PLANNING REPORT

Administrative Review Team

R-1 – Avery Water Tower Verizon 26-056ARTW

Existing Antenna Layout

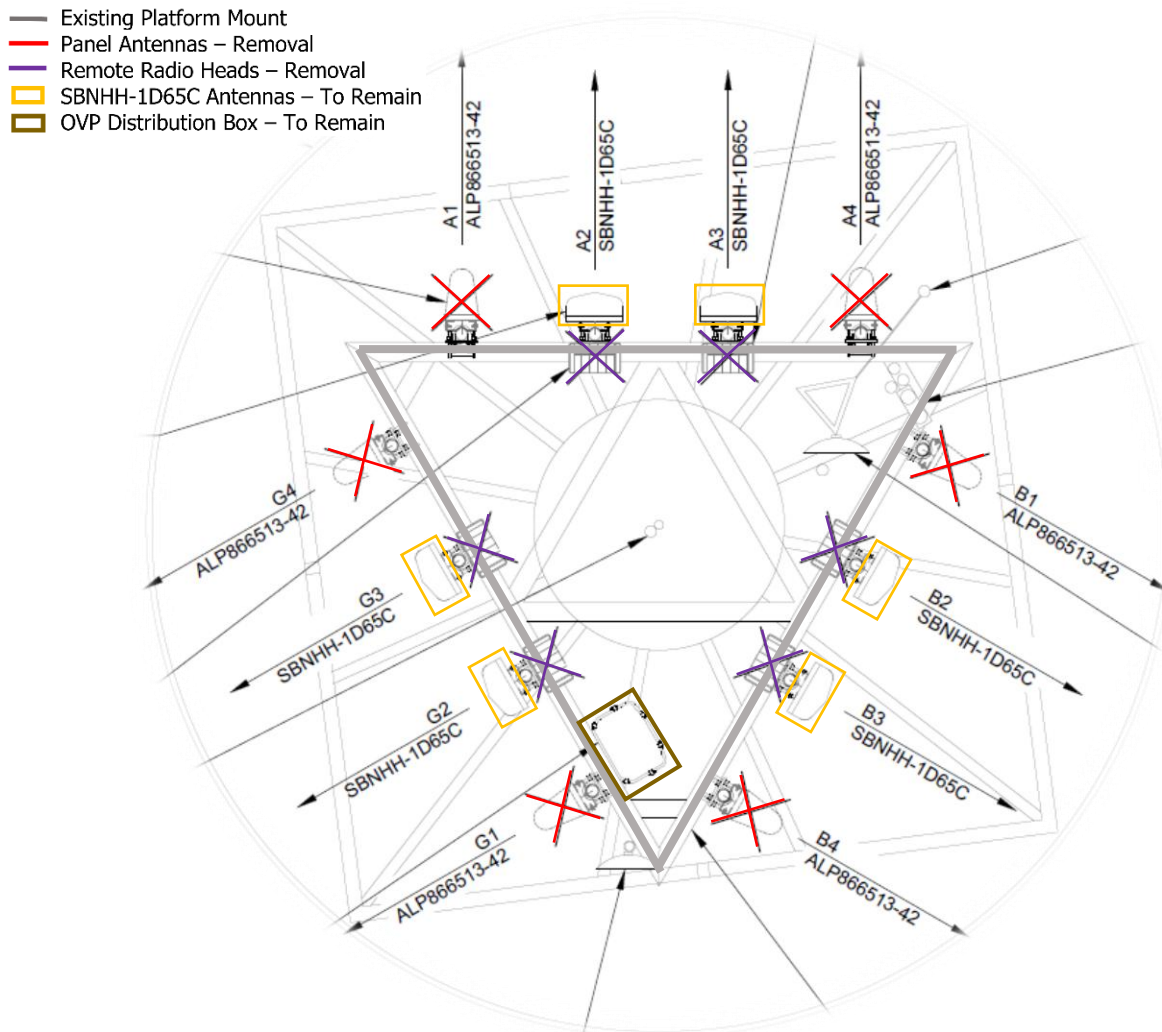
- 6 existing panel antennas
- 6 existing remote radio heads
- 1 existing spare coax cable

Proposed Antenna Layout

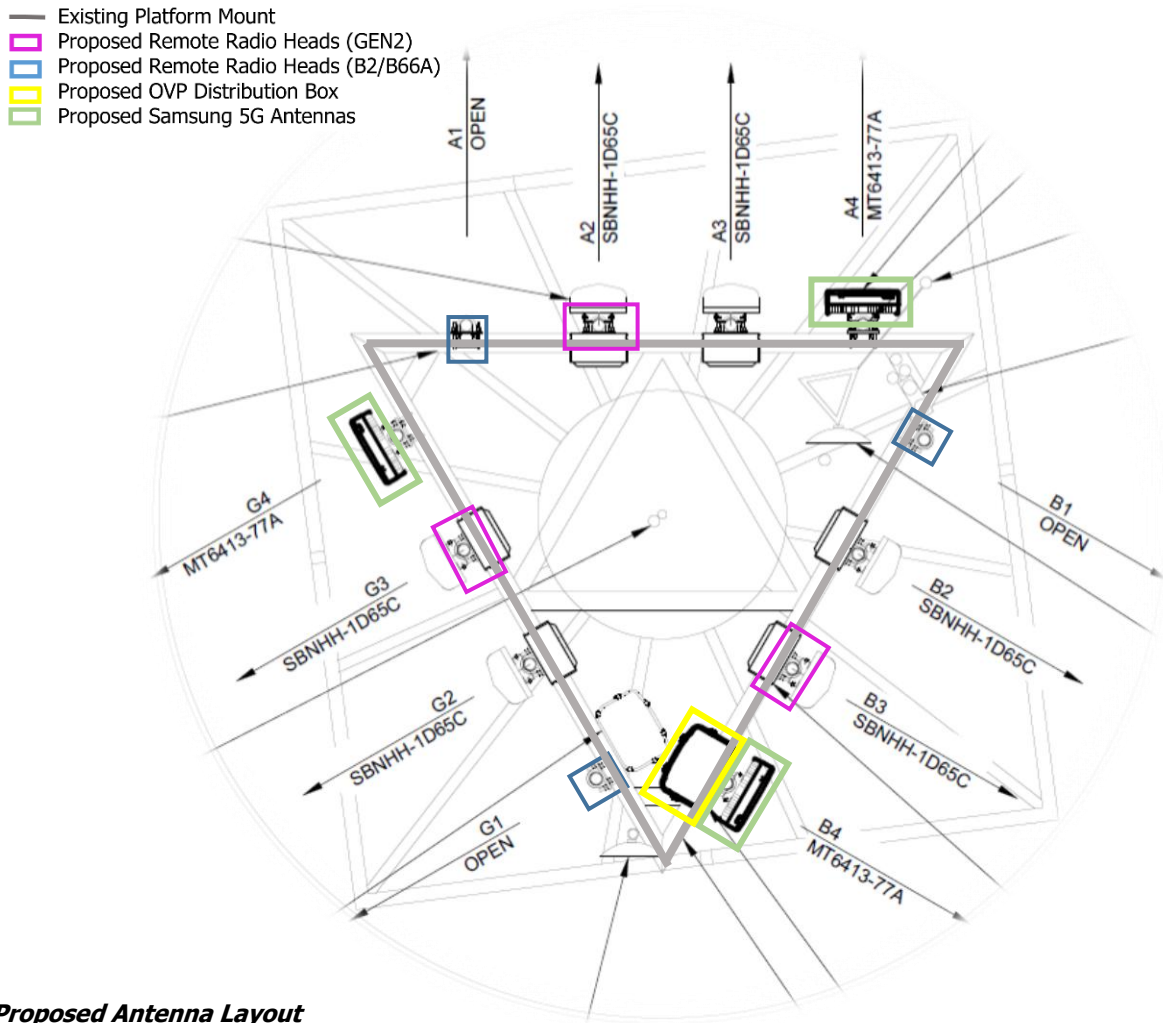
Chapter 99 requires that towers, antennas, other wireless communications facility support structures and supporting electrical and mechanical equipment shall either maintain a non-contrasting gray or similar color or have a galvanized steel finish unless otherwise required by the reviewing body or any applicable standards of the FAA and/or the Ohio Department of Transportation. Planning Staff recommends that the antennas and associated equipment maintain a color that is identical or closely compatible with the galvanized steel of the existing pole. Additionally, any associated cables should be trimmed to fit closely to the tower.

2. The color and design of the co-located antenna is consistent with the existing tower and is designed to be as unobtrusive as possible.	Criterion Met with Condition. The existing antenna and RRH equipment are a light color consistent with the tower's white finish. Planning Staff recommends all new antennas and equipment maintain a color that is identical or closely compatible with the color of the existing structure. Additionally, any associated cables should be trimmed to fit closely to the structure.

- 1) The antennas and associated equipment shall maintain a neutral color that is identical to, or closely compatible with, the color of the supporting structure; and
- 2) Any associated cables should be trimmed to fit closely to the structure.
